UNITED STATES PATENT AND TRADEMARK OFFICE

APPLICATION NO.	FILING DATE	FIRST NAMED INVENTOR	ATTORNEY DOCKET NO.	CONFIRMATION NO.
10/670,985	09/25/2003	Jaime L. Rugnetta	279.607US1	4509

Office Action Summary

DETAILED ACTION

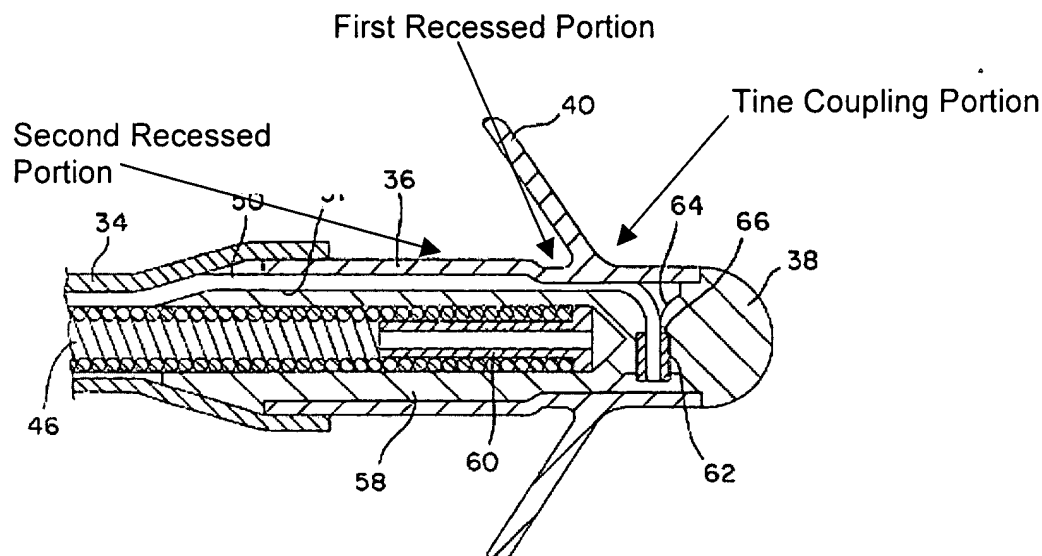
Huepenbecker et al. discloses a lead having at least one tine (40) coupled at the distal end thereof. The tines have a first position extended away from the lead body (as shown in Figure 4 reproduced below). In addition, although not explicitly stated, the tines necessarily have a second collapsed position because the tines are formed of a flexible material such that the tines fold/collapse against the lead body during insertion into the patient. The lead includes two recessed portions, as indicated on Fig. 4 reproduced below. The first recessed portion is longitudinally disposed between the tine coupling portion and the second recessed portion, as shown below. In addition, when the tines collapse during implantation, the first recessed portion would necessarily be recessed away from the bottom surface of the tine.

With respect to claim 4, it appears from Figure 4 that the cross-sectional area at the lead distal end (between electrode 38 and the tine- coupling portion) is approximately the same as the cross-sectional area of the tine coupling portion. Accordingly, the cross-sectional area of the tine coupling area is necessarily "less than 10% smaller" than the cross-sectional area of the lead distal end.

With respect to claim 7, Examiner considers spacer 34 shown on Figure 4 to be an "intermediate portion of the lead body." As shown in Fig. 4, the diameters of the

spacer 34, the first recessed portion, and the second recessed portion are each different from one another.

With respect to claim 8, the cross-sectional area of the first recessed portion is smaller than the cross-sectional area of the second recessed portion. As such, Examiner considers the first cross-sectional shape to be different from the second cross-sectional shape. In the alternative, Examiner notes that the 103 rejection below for claims 17-18 relate to modifying the first and/or second recessed areas to be non-circular (thus resulting in the first cross-sectional shape being different from the second cross-sectional shape).

With respect to the rejection of claim 8 based on Huenpenbecker, the cross-sectional area of the first recessed portion is illustrated in Figure 4 as smaller than the cross-sectional area of the second recessed portion. As such, Examiner considers the first cross-sectional shape to be different from the second cross-sectional shape. In the alternative, Examiner notes that the 103 rejection above for claims 17-18 relate to modifying the first and/or second recessed areas to be non-circular (thus resulting in the first cross-sectional shape being different from the second cross-sectional shape).

One of Applicant's arguments appears to be that since Huenpenbecker does not state that the drawings are to scale, the Figure 4 of Huenpenbecker cannot anticipate the claims of the present invention. Examiner notes that the claims as written do not require any precise proportions or sizes of the first and second recessed portions. Although patent drawings which are not disclosed as drawn to scale may not be relied on to show particular sizes if the specification is completely silent on the issue, the drawings and pictures can anticipate claims if they clearly show the structure which is claimed. See MPEP 2125. Examiner considers Fig. 4 of Huenpenbecker to clearly show claimed structures of the present invention: the lead body, at least one tine, and the first and second recessed portions formed on the lead body.

**FIG. 5**

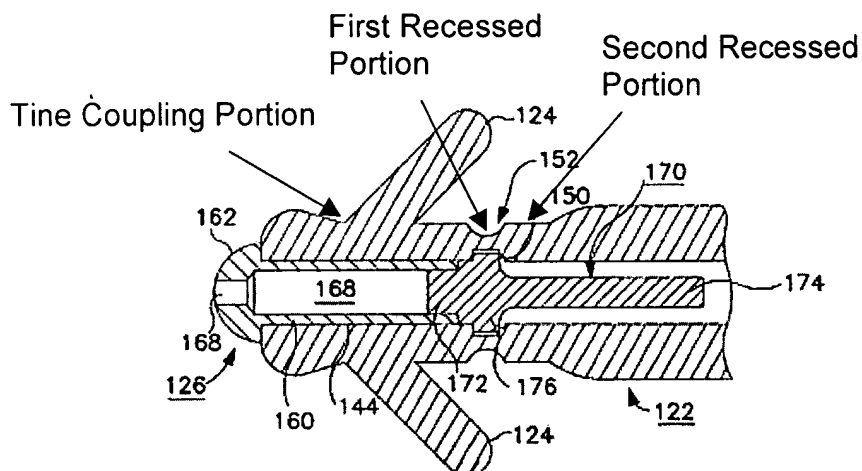
Laske et al. discloses a lead having at least one tine (124) coupled at the distal end thereof. The tines have a first position extended away from the lead body (as shown in Figure 5 reproduced below). In addition, although not explicitly stated, the tines necessarily have a second collapsed position because the tines are formed of a soft, pliant material such that the tines fold/collapse against the lead body during insertion into the patient (see col. 5, lines 23-37). The lead includes two recessed

portions, as indicated on Fig. 5 reproduced below. The first recessed portion is longitudinally disposed between the tine coupling portion and the second recessed portion, as shown below. In addition, when the tines collapse during implantation, the first recessed portion would necessarily be recessed away from the bottom surface of the tine.

With respect to claim 4, it appears from Figure 5 that the cross-sectional area at the lead distal end is slightly larger than the cross-sectional area of the tine coupling portion. Examiner considers the cross-sectional area of the tine coupling area to be approximately "less than 10% smaller" than the cross-sectional area of the lead distal end.

With respect to claim 7, Examiner considers tubular sheath 122 shown on Figure 5 to be an "intermediate portion of the lead body." As shown in Fig. 5, the diameters of the sheath 122, the first recessed portion, and the second recessed portion are each different from one another.

With respect to claim 8, the cross-sectional area of the first recessed portion is smaller than the cross-sectional area of the second recessed portion. As such, Examiner considers the first cross-sectional shape to be different from the second cross-sectional shape. In the alternative, Examiner notes that the 103 rejection below for claims 17-18 relate to modifying the first and/or second recessed areas to be non-circular (thus resulting in the first cross-sectional shape being different from the second cross-sectional shape).

With respect to the rejection of claim 8 based on Laske, the cross-sectional area of the first recessed portion is illustrated in Figure 5 as smaller than the cross-sectional area of the second recessed portion. As such, Examiner considers the first cross-sectional shape to be different from the second cross-sectional shape. In the alternative, Examiner notes that the 103 rejection above for claims 17-18 relate to modifying the first and/or second recessed areas to be non-circular (thus resulting in the first cross-sectional shape being different from the second cross-sectional shape).

One of Applicant's arguments appears to be that since Laske does not state that the drawings are to scale, the Figure 5 of Laske cannot anticipate the claims of the present invention. Examiner notes that the claims as written do not require any precise proportions or sizes of the first and second recessed portions. Although patent drawings which are not disclosed as drawn to scale may not be relied on to show particular sizes if the specification is completely silent on the issue, the drawings and pictures can anticipate claims if they clearly show the structure which is claimed. See MPEP 2125. Examiner considers Fig. 5 of Laske to clearly show claimed structures of the present invention: the lead body, at least one tine, and the first and second recessed portions formed on the lead body.
